## SMYRNA MUNICIPAL PLANNING COMMISSION

### MEETING MINUTES JANUARY 4, 2024

1. Addition to Villages of Valley Green, Section IV - **Request to be deferred**  
 Enon Springs Road W & Wildwood Drive  
 Owner / Developer: JSD Holdings

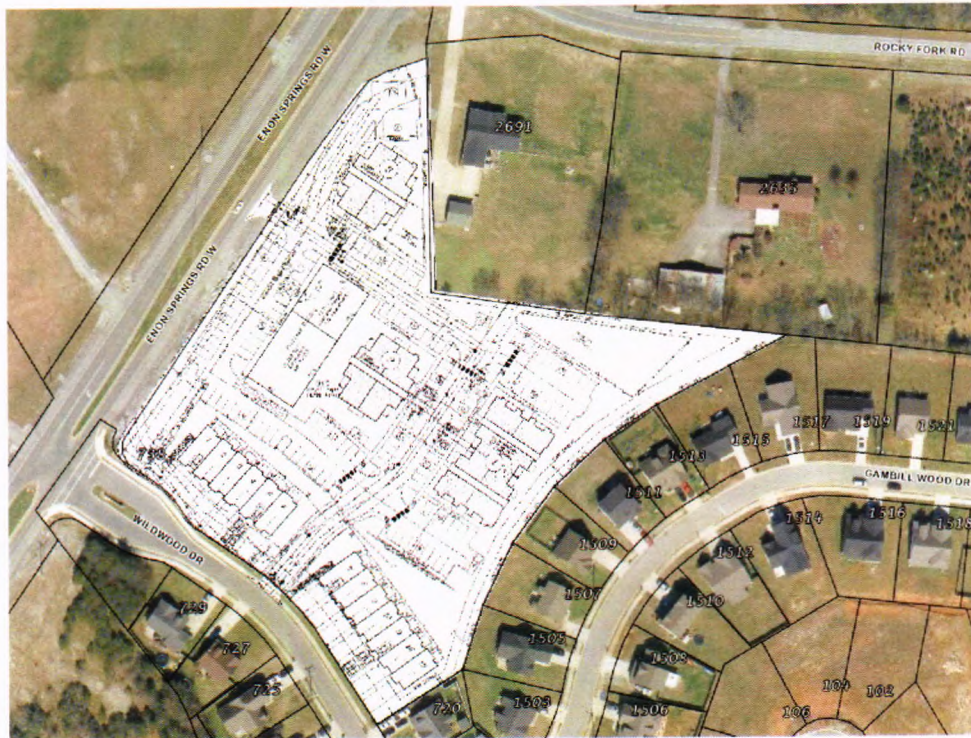
1. Construction plans are under review.
2. Landscaping along Enon Springs Road, West will be required to comply with MTEMC overhead utility requirements.

3. Provide the square footage of the townhomes in order to calculate the correct required fire flow. Depending on the proposed square footage, buildings may be required to be sprinkled.

4. Staff would recommend that the privacy fence be constructed of a different product than wood for durability purposes.
5. Ensure the sidewalk corners meet ADA requirements.

6. Ensure the storm system intercepts flow from impervious surfaces on site and are directed to the pond.
7. Ensure all storm structures are located in a clearly marked drainage easement or common area.

8. Drainage structures and landscape buffers must not overlap.
9. Extend sewer to the Walter Gambill property.
10. Any balcony or covered area must meet minimum building setbacks.

11. Show an example of the playground equipment to be used in playground areas.
12. This site is part of a PUD which was approved several years ago which allowed for 60 multifamily units. There were no specifics within the PUD as to the type of multifamily units. The required parking at the time of PUD approval for all multifamily units was 2 spaces per unit. Since that time, the Town has amended the parking requirements for townhome developments to 4 spaces per unit plus .5 space per unit for guest parking. This translates to 270 parking spaces which would be required for this development. As shown, 13 units have 4 driveway spaces, 23 units have 2 driveway spaces, and 24 units have 1 driveway space. In addition, there are 40 surface parking spaces. This totals 162 spaces. The site as proposed does not meet current parking requirements for townhomes. The required parking for apartments remains 2 spaces per unit.

1. Legends of Smyrna, Lot 4A  
Almaville Road  
Owner / Developer: Fleeman Living Trust / Greg Patel

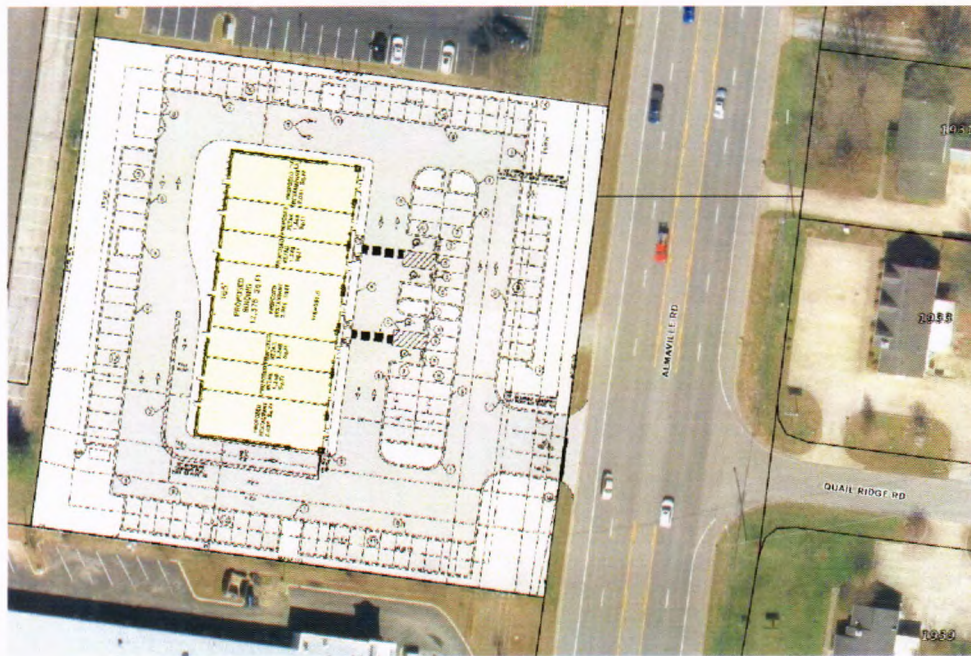
1. As submitted, the required minimum fire flow is 1,500 GPM at 20 PSI.
2. It appears that the dumpster enclosure is set up for two dumpsters for potentially seven businesses including potentially three restaurants. If this proves to be inadequate and additional dumpsters are needed in the future, the enclosure will have to be rebuilt to enclose all needed

- dumpsters.
3. Expand the dumpster enclosure to include a 3rd dumpster.
  4. Provide TDOT approval for driveway entrance off of Almaville Road prior to issuance of a building permit.

5. There is a possibility that in the future the center turn lane of Almaville Road may be removed. At that time, the access to this site would become a right in/out only.

6. Adequate parking is shown to meet the Zoning Ordinance. However, the area of the building which is able to be used as a restaurant is limited to 7,000 square feet in order to maintain adequate parking for the site.

7. The proposed plan for stormwater detention exclusively utilizing pervious pavers will be reviewed with the grading permit.
  8. CUD's existing infrastructure should be adequate to meet the 1,000-1,500 GPM fire flow requirement for this site.

2. The Courtyards at Stewarts Creek Amenity Area  
Rocky Fork Almaville Road  
Owner / Developer: EPCON Communities

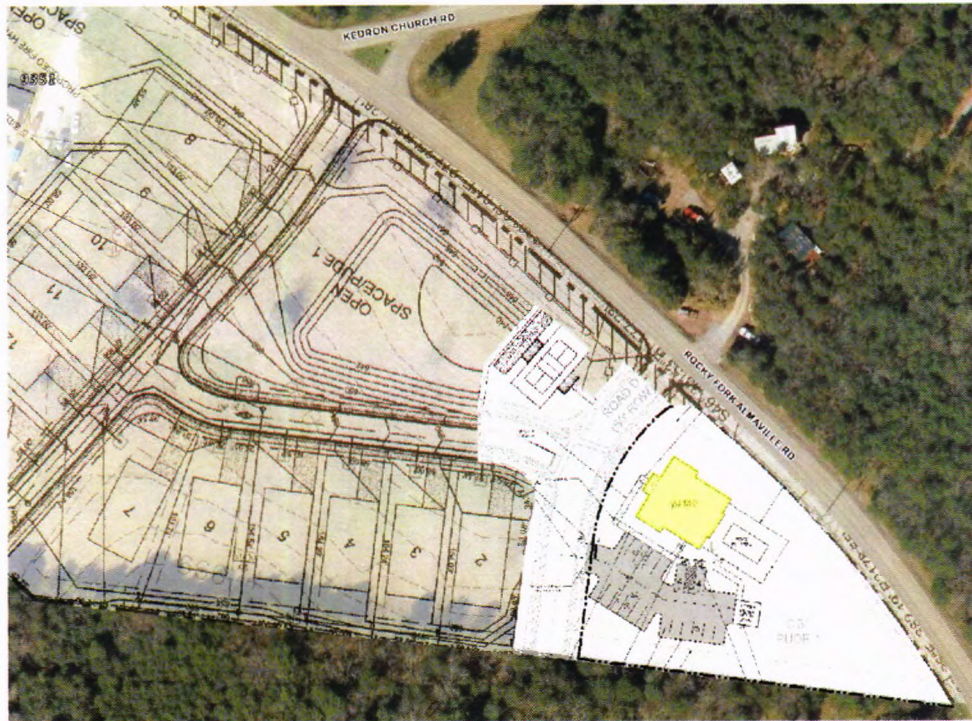
1. Provide streetscaping along Road D between the parking lot and the road meeting Design

- Review requirements.
2. Label all road names and provide E911 approval.
  3. The required minimum fireflow is 1500 GPM at 20 PSI. If the building is sprinkled, it would be 1000 GPM at 20 PSI.

4. The building is required to be sprinkled.
  5. The FDC must be 30' from the building and fire hydrants must be within 100' of the FDC.
  6. A final plat must be submitted and recorded prior to issuance of a building permit.

7. Please modify the Type C landscape buffer along Rocky Fork Almadillo Road to streetscaping per our Design Review Manual.
  8. Landscaping and drainage structures may not overlap. Please shift landscaping away from the drainage ditch.

9. CUD's existing infrastructure should be adequate to meet 1,000 GPM flow requirement for this site. Please refer to CUD Will Serve letter issue 2/27/2023. If the fire flow requirement is greater than 1,000 GPM, please resubmit a water availability request for further evaluation and to receive an updated Will Serve letter.
